Committee of Experts on the Transport of Dangerous Goods and on the Globally Harmonized System of Classification and Labelling of Chemicals

Sub-Committee of Experts on the Transport of Dangerous Goods

Review of the Manual of Tests and Criteria

Transmitted by the Chairman of the Working Group on Explosives

Figure 11.4.1.1: UN GAP TEST

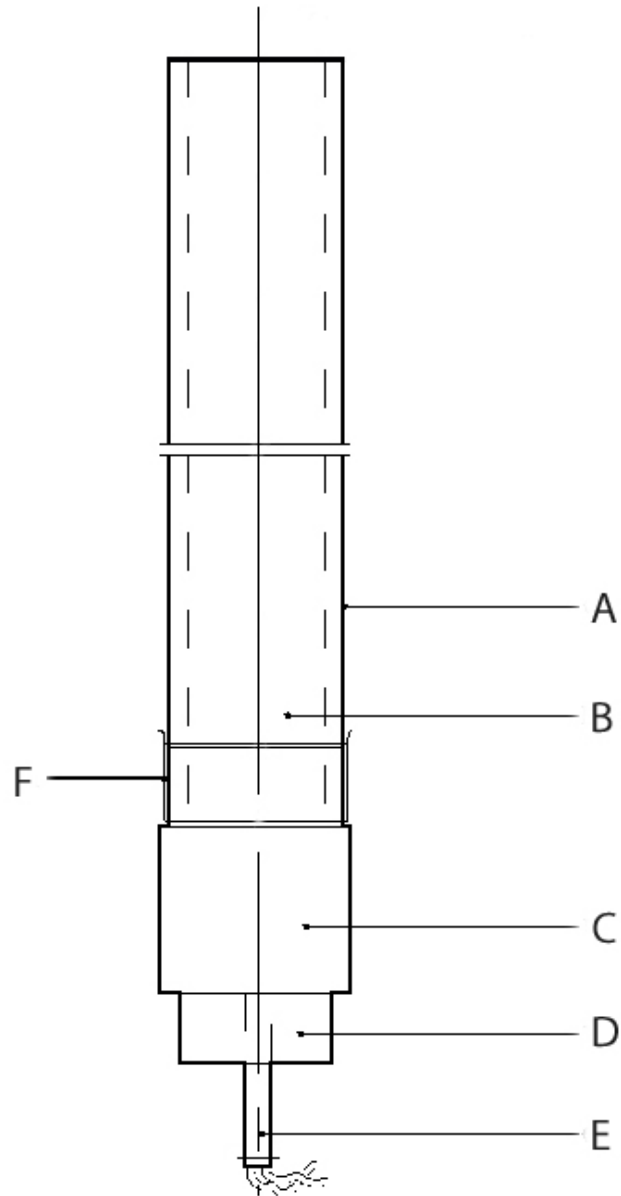
| (A) | Spacers | (B) | Witness plate |
| (CA) | Steel tube | (DB) | Substance under investigation |
| (EC) | RDX/wax or PETN/TNT booster charge | (FD) | Detonator holder |
| (GE) | Detonator | (HF) | Plastics membrane |

Figure 12.4.1.1: UN GAP TEST

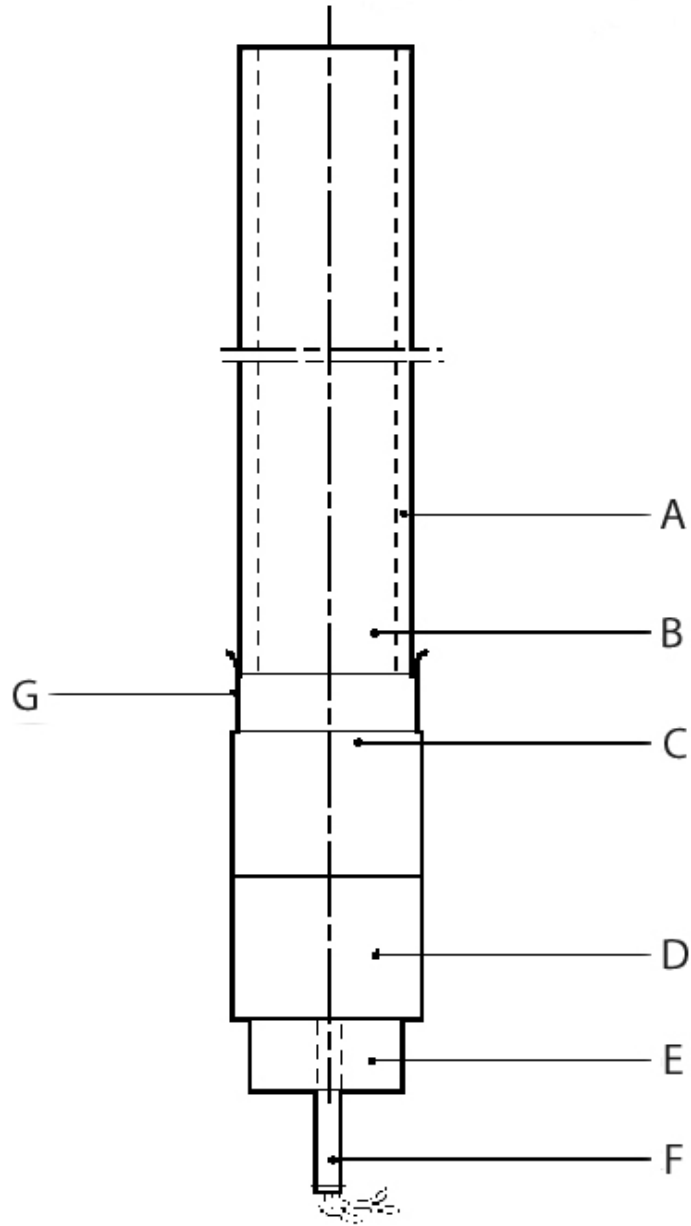
| (A) (A) Spacers | (B) (B) Witness plate |
| (C) (C) Steel tube | (D) (D) Substance under investigation |
| (E) (E) PMMA spacer | (F) (F) RDX/wax or PETN/TNT booster charge |
| (G) (G) Detonator holder | (H) (H) Detonator |
| (I) (I) Plastics membrane | |

Figure 21.4.3.1: UN GAP TEST

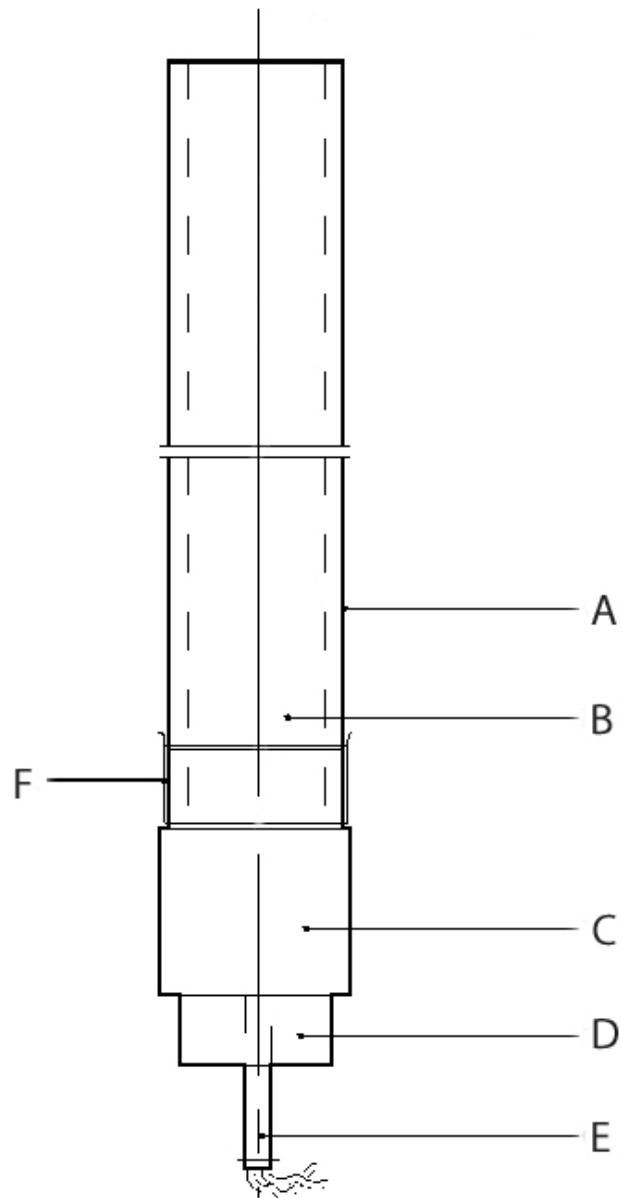
| (A) | Spacers | (B) | Witness plate |
| (CA) | Steel tube | (DB) | Substance under test |
| (EC) | RDX/wax or PETN/TNT booster charge | (FD) | Detonator holder |
| (GE) | Detonator | (HF) | Plastics sheet |

Figure 21.4.4.1: UN DETONATION TEST

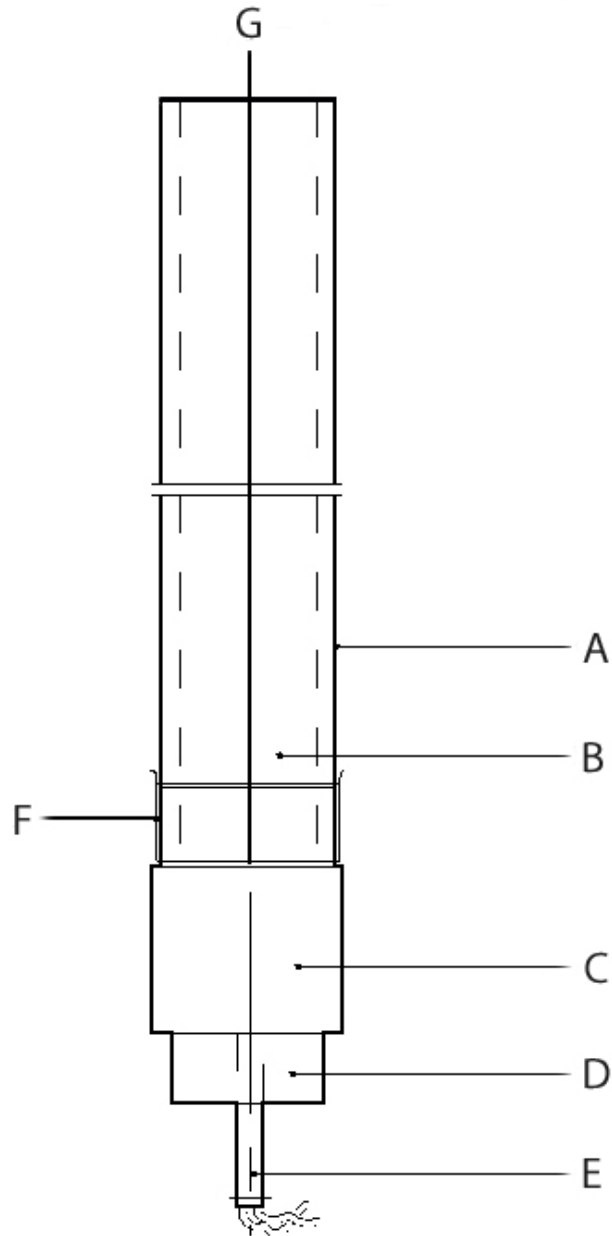
| (I) | Velocity probe <u>(optional)</u> | | |
